30 Denewood, London, N6 4AH

Proposed Elevations

Dwg No.: 1182 / AP2 - 04a Scale: 1:100 @ A1, 1:200 @ A3

30 Denewood Road, London N6 4AH.
 Proposed Plans 1182 / AP3 - 02

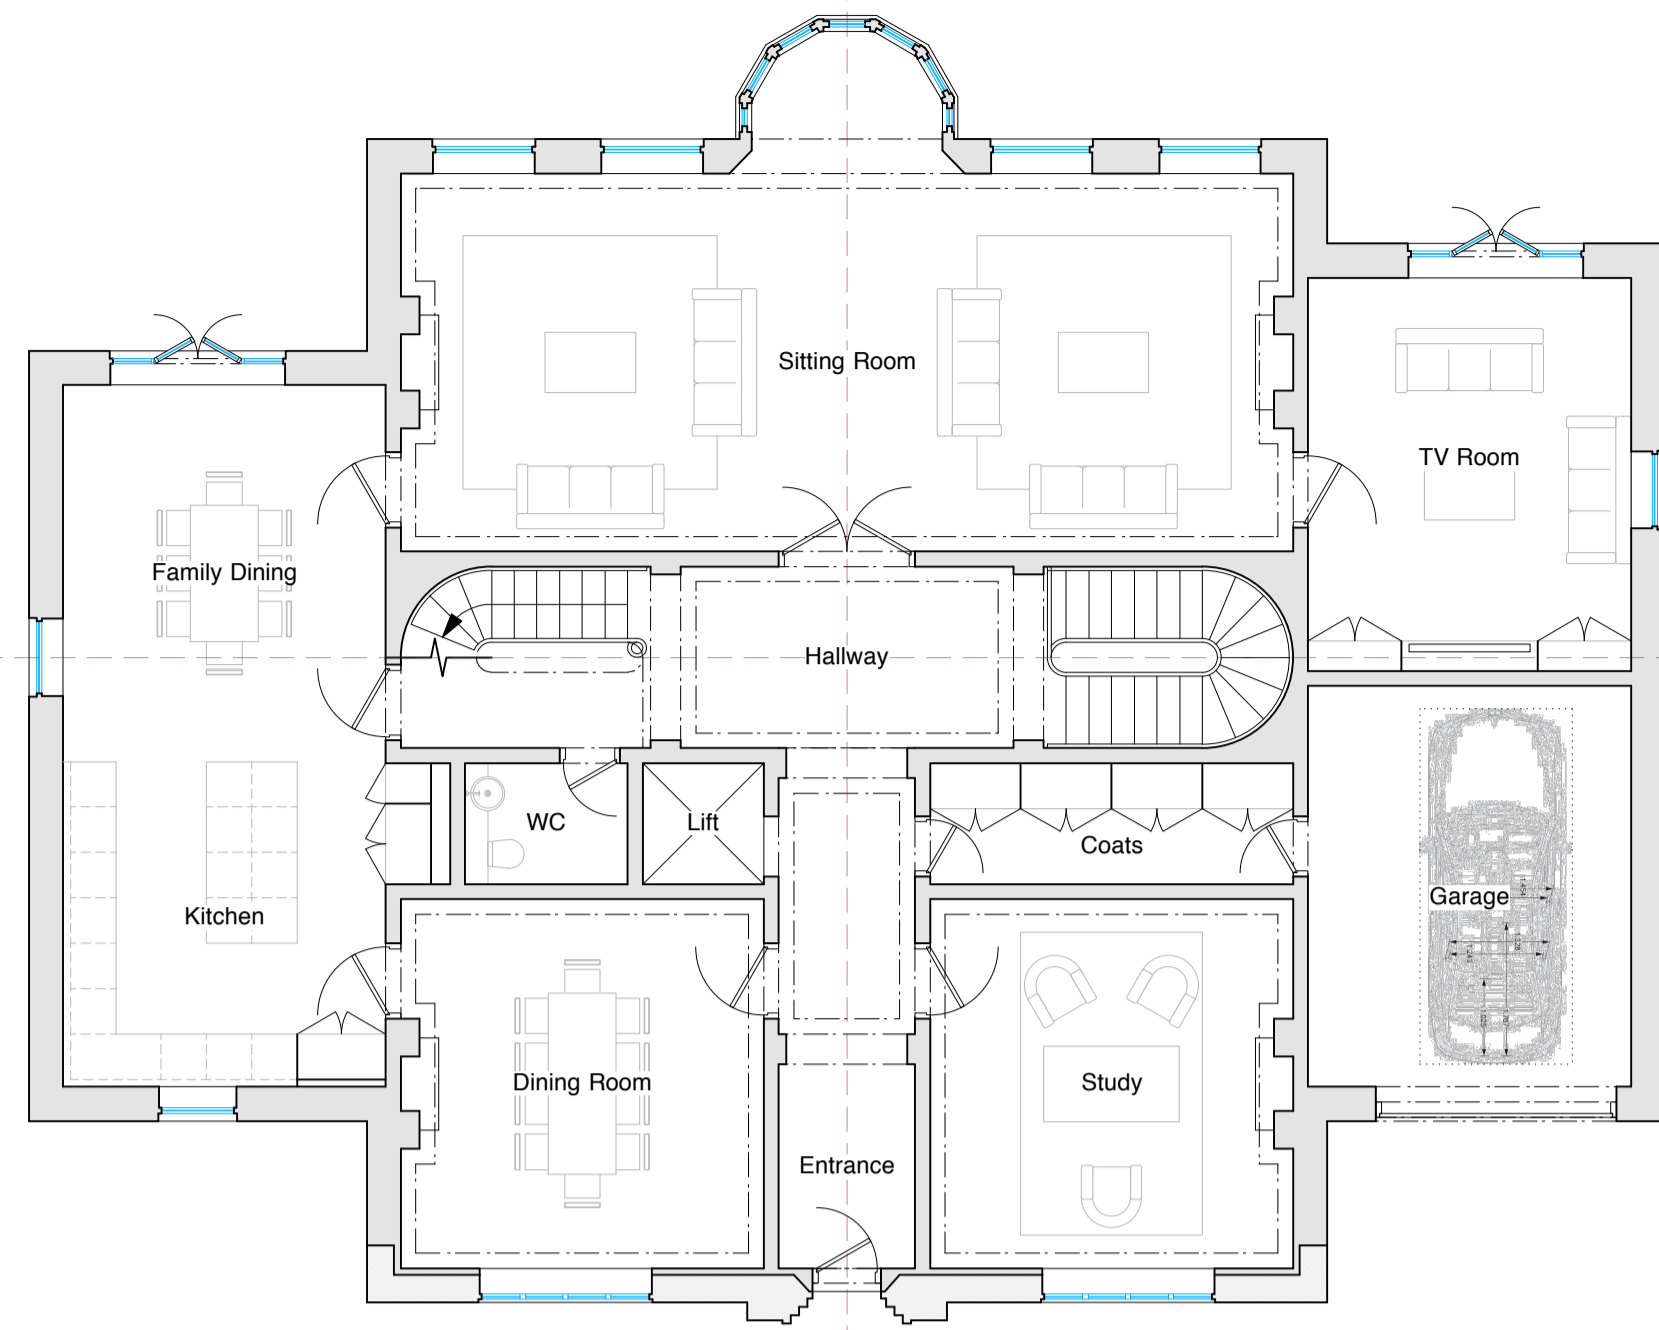
New application incorporating the following changes, which were requested by the Local Authority.

- Removal of the central dormer on the front elevation.
- Simplification of the door case.
- Chimneys decreased in size and simplified.
- Front facade retained.
- Basement reduced so that it extends only 4m beyond the main rear building line.

Basement Plan

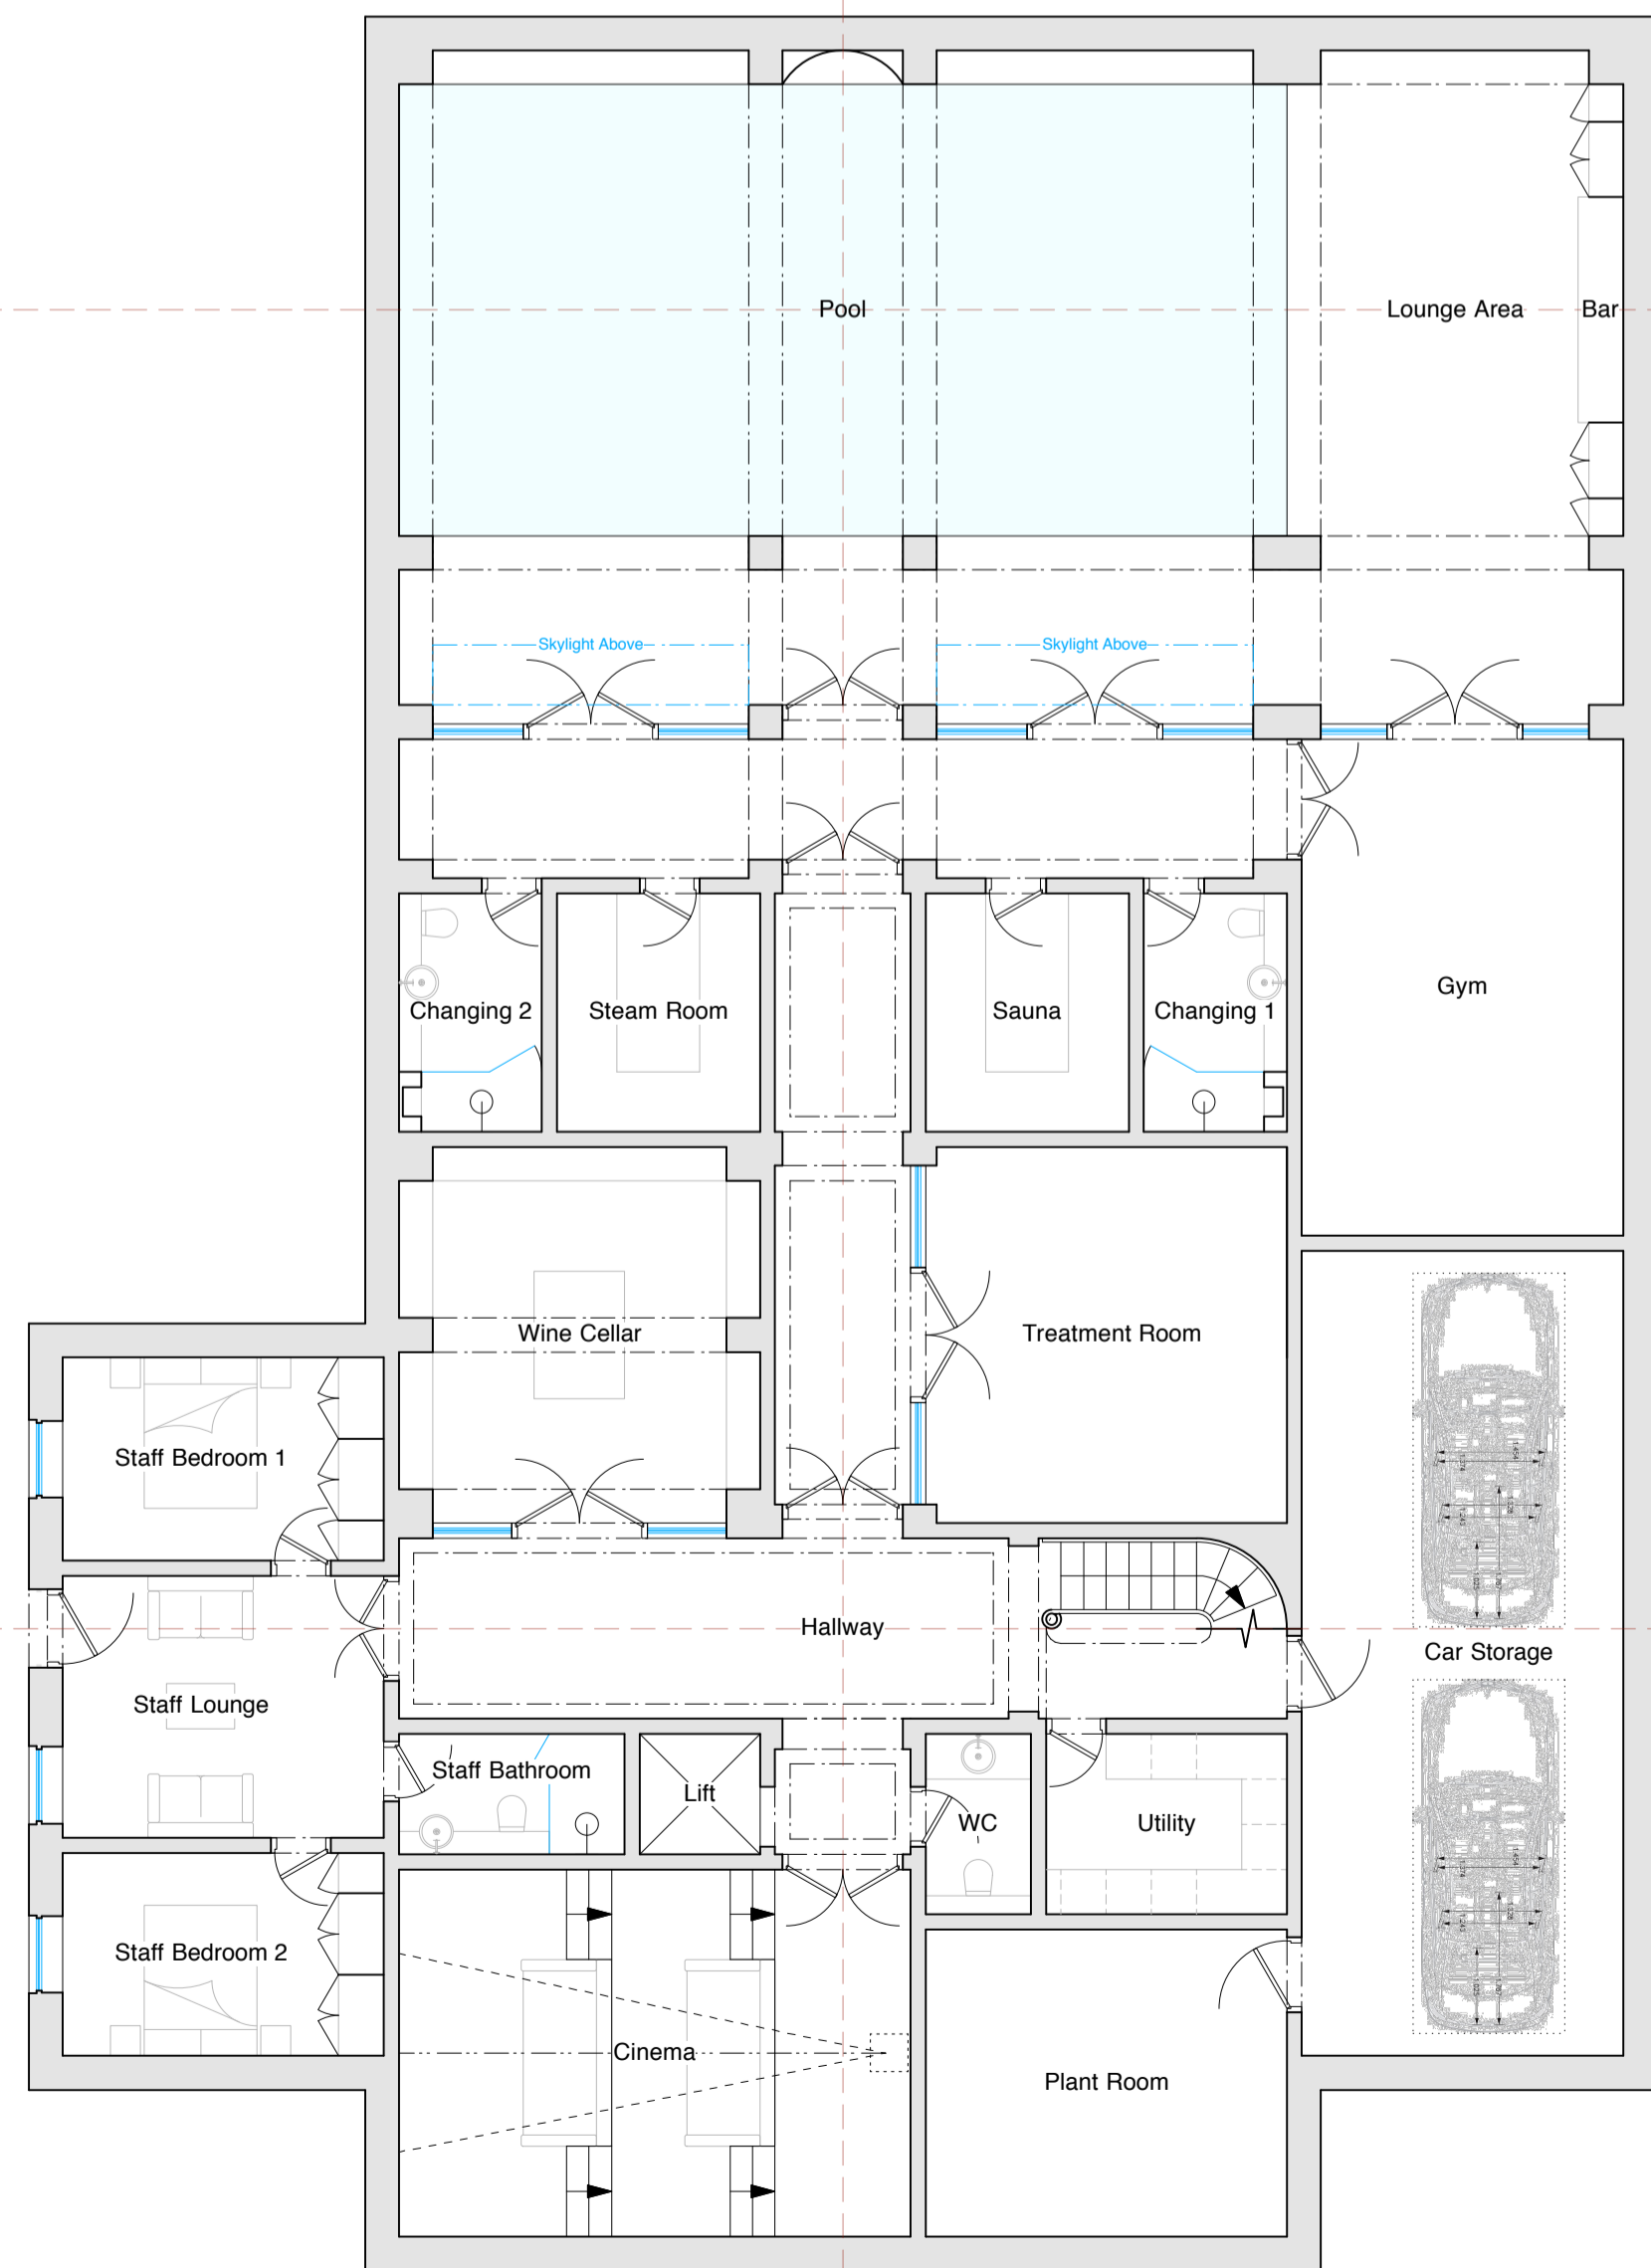
- New application incorporating the following changes, which were requested by the Local Authority.
- Removal of the central dormer on the front elevation.
 - Simplification of the door case.
 - Chimneys decreased in size and simplified.
 - Front facade retained.
 - Basement reduced so that it extends only 4m beyond the main rear building line.
